**COUNTY OF SAN MATEO
PLANNING AND BUILDING DEPARTMENT**

SUBJECT: EXECUTIVE SUMMARY: Consideration of a Coastal Development Permit (CDP), Resource Management-Coastal Zone Permit, Resource Management Permit, Planned Agricultural District Permit, Use Permit, Use Permit Renewal, Variance, Design Review, Grading Permit, and adoption of a Mitigated Negative Declaration, to continue operation of an existing Sprint PCS wireless facility, legalize an existing unpermitted AT&T Wireless facility, repair eroded sections of an existing 3.5-mile dirt access road, including 2,065 cubic yards of cut, the installation of four new firetruck turnouts, and authorize an existing substandard right side yard setback; no tree removal is proposed. The project is located atop of Montara Mountain in the unincorporated Montara area of San Mateo County. The CDP is appealable to the California Coastal Commission.

County File Number: PLN2006-00075 (Sprint PCS) and PLN2017-00135 (AT&T Wireless) (Murray/Belair)

SHEET NUMBER:
C-405

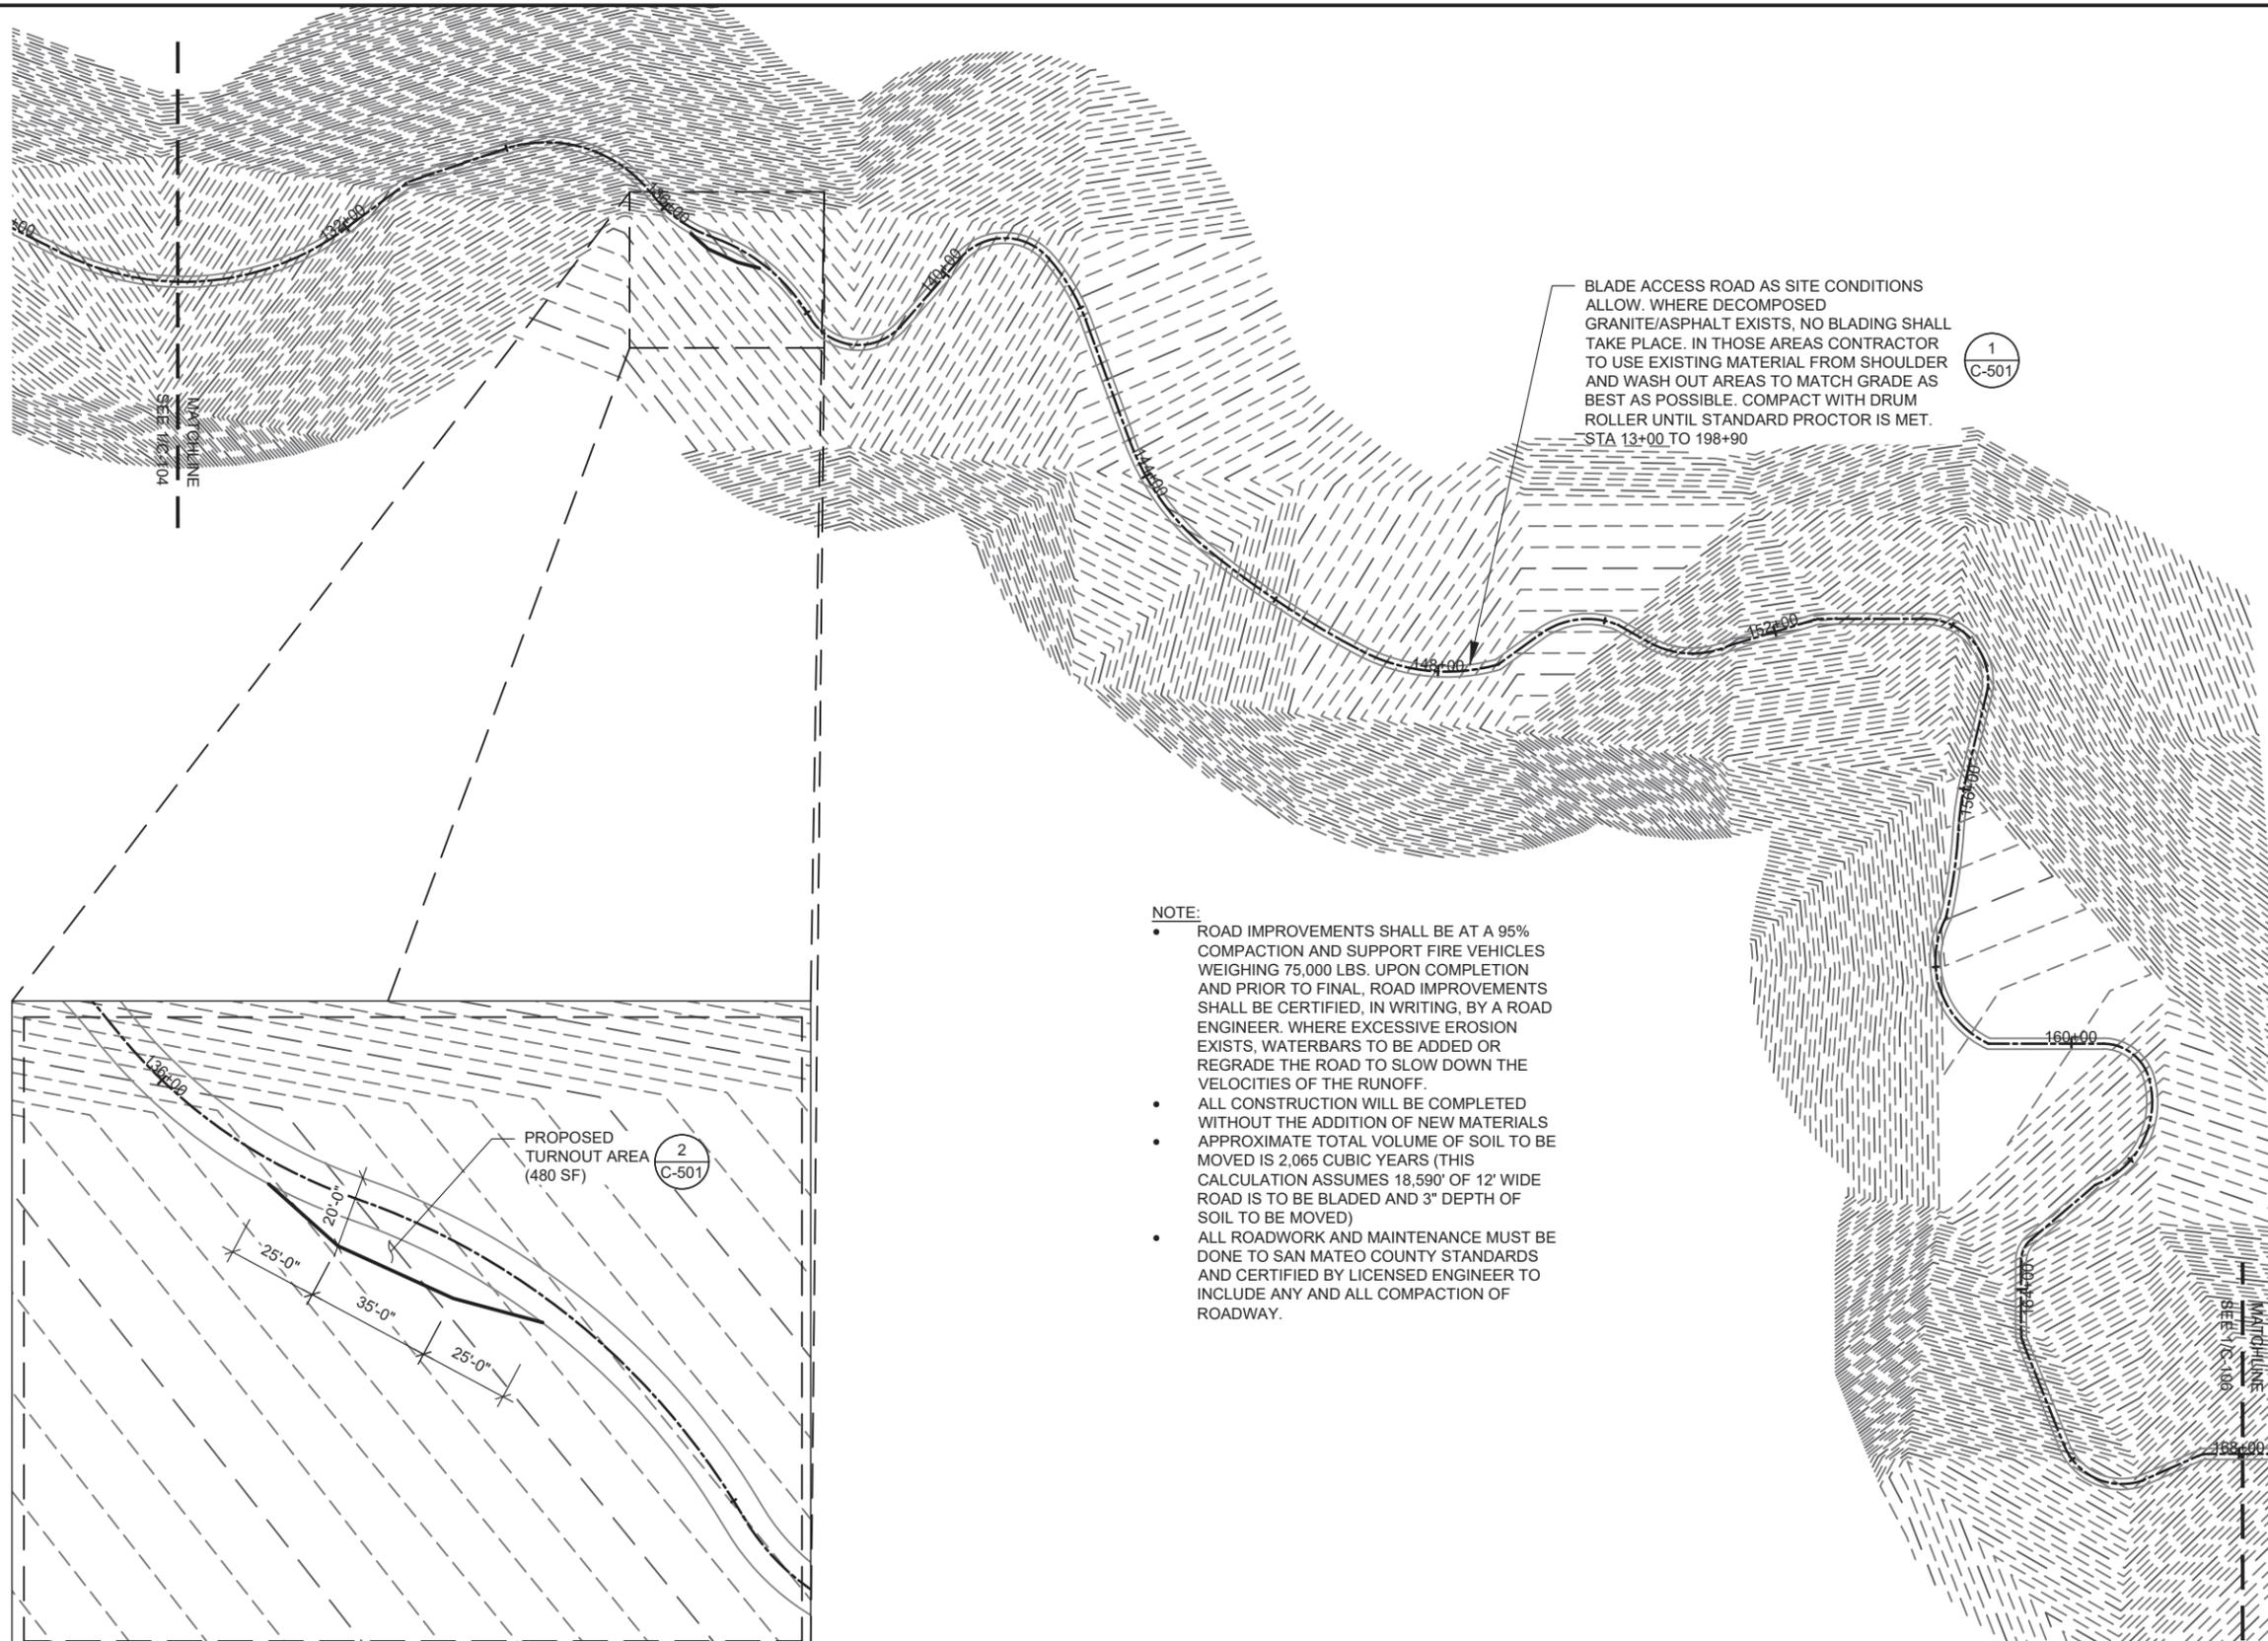
Staff received a comment letter (dated May 11, 2023, Attachment I) from State Parks in response to the revised IS/MND. State Parks requested the following: a) that ATC revise the location of the turnout on plan sheet C-405 and relocate the turnout to a different location, approximately 130 feet away, in order to reduce biological impacts - the recommended relocation area is a large flat open space, and b) that ATC amend their agreement with State Parks to allow the proposed repair and grading.
